Independent Review of Flood Modelling Undertaken for the Macintyre River Floodplain

Inland Rail Project - Border to Gowrie (B2G)

Goondiwindi Regional Council
1283-02-E, 29 April 2021

Figure 7-9 - Updated flood impacts for the 1% AEP design event

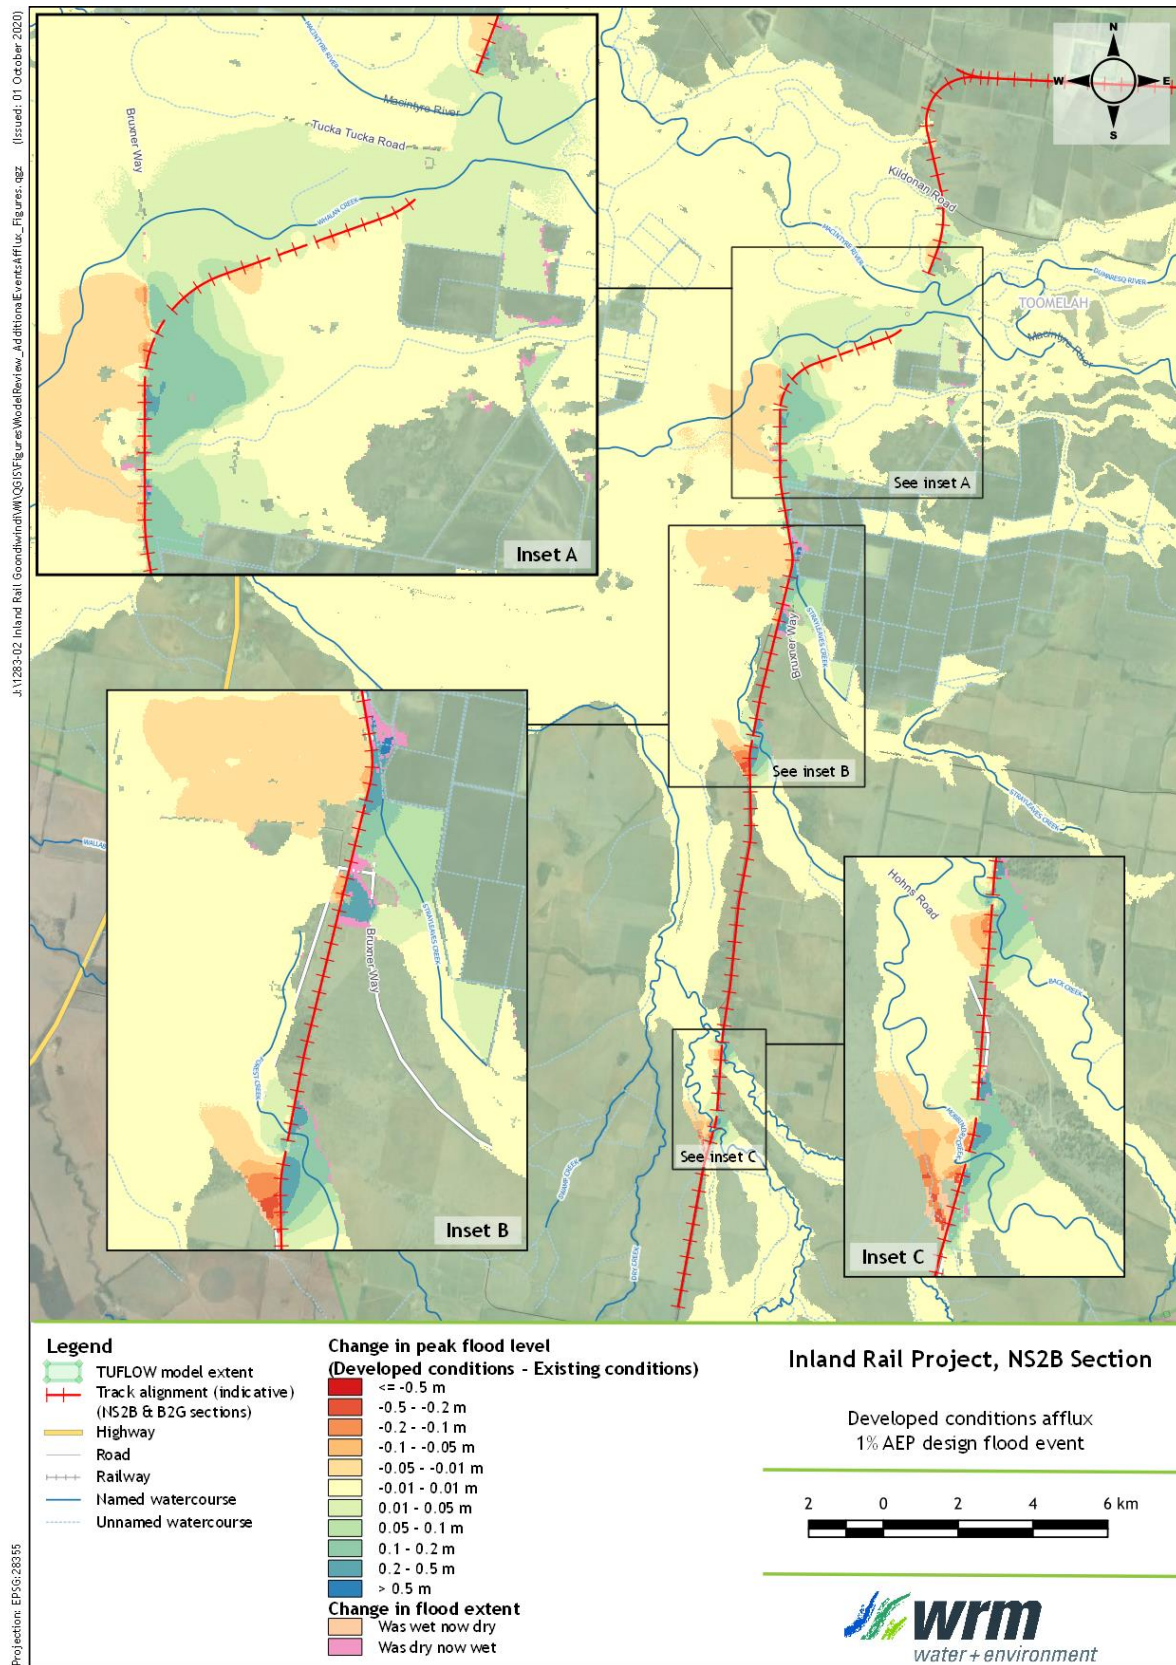
Figure 7-5 to Figure 7-9 show the updated flood impact maps for 20% AEP to 1% AEP design flood events along the NS2B alignment, including the locations where the impacts exceed the flood impact objective limits. These flood maps also show that:

- At the Mobbindry Creek crossing, there are upstream impacts that are greater than the established flood impact objective limits upstream of the rail line for all flood events shown.

- For the mapped events, the flood impacts generally increase with flood magnitude.
 - There are some localised areas with impacts greater than 0.5 m for the larger flood events.
